T2S CHANGE REQUEST FORM		
General Information (Origin of Request) <input checked="" type="checkbox"/> User Requirements (URD) or GUI Business Functionality Document (BFD) <input type="checkbox"/> Other User Functional or Technical Documentation (SYS)		
Request raised by: Deutsche Bundesbank on behalf of the German NSGs	Institute: Central bank	Date raised: 12/12/2022
Request title: Harmonisation of floor/ceiling notifications with T2		Request No: T2S 0800 URD
Request type: Common	Classification: Scope enhancement	Urgency: Normal
1. Legal/business importance parameter¹: Medium	2. Market implementation efforts parameter²: Low	
3. Operational/Technical risk parameter³: Low	4. Financial impact parameter⁴: Medium	
Requestor Category: Central bank		Status: Implemented

T2S should be aligned with T2 in order to just send one notification after breaching the threshold. T2S should not send the notification again if, after having passed the threshold, the balance of the T2S DCA remains consistently below the floor or above the ceiling threshold defined.

DIAGRAM 151 - FLOOR CEILING NOTIFICATION

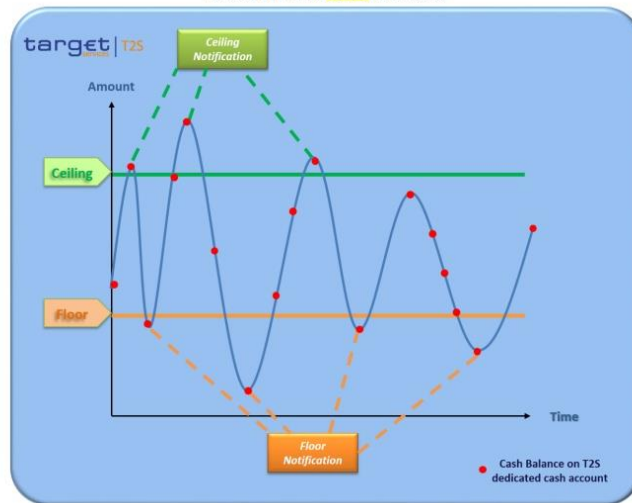
The notifications are sent continuously after each and every securities settlement as well as after liquidity transfers when the threshold value has been reached. In certain constellations, this leads to a veritable “flood” of camt.004 notifications that arrive within seconds.

As a practical consequence, this leads to the current status where the T2S floor/ceiling functionality is only rarely used in production, especially because each camt.004 is subject to a charge (transmission item), additional NSP costs and generates redundant expenses in banks' backend applications.

Figure 43 - Breach of floor/ceiling threshold - notification

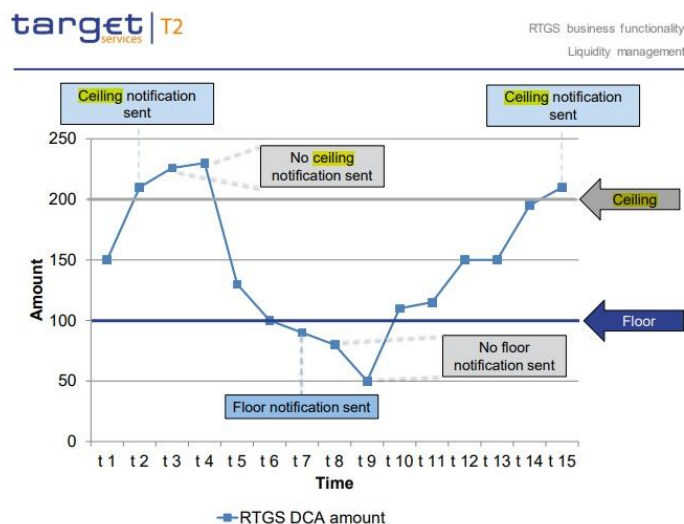
For the T2 CLM/RTGS and TIPS services, the following applies concerning the floor/ceiling notification functionality: The notification is sent only once for every threshold breach, i.e., RTGS/CLM/TIPS does not send the notification again if, after having passed the threshold, the balance of the RTGS DCA/CLM MCA or TIPS DCA remains consistently below the floor or above the ceiling threshold defined.

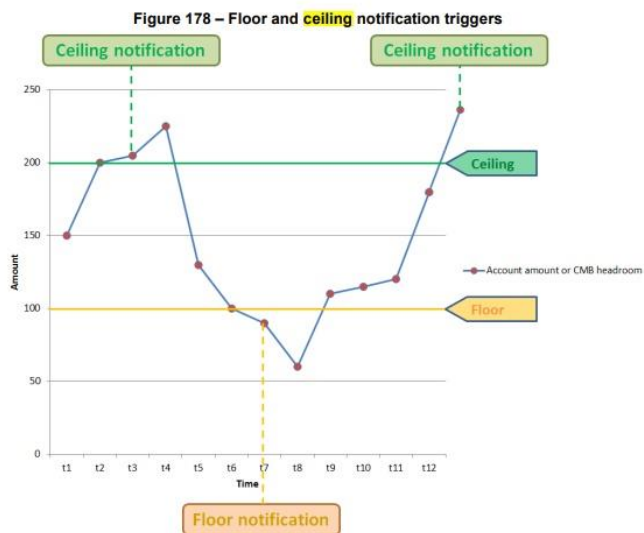
The notifications are generated every time the threshold is undercut (floor) or exceeded (ceiling). TIPS does not generate new notifications if, after trespassing the threshold, the account balance or the CMB headroom remains consistently above the ceiling threshold or below the floor threshold.
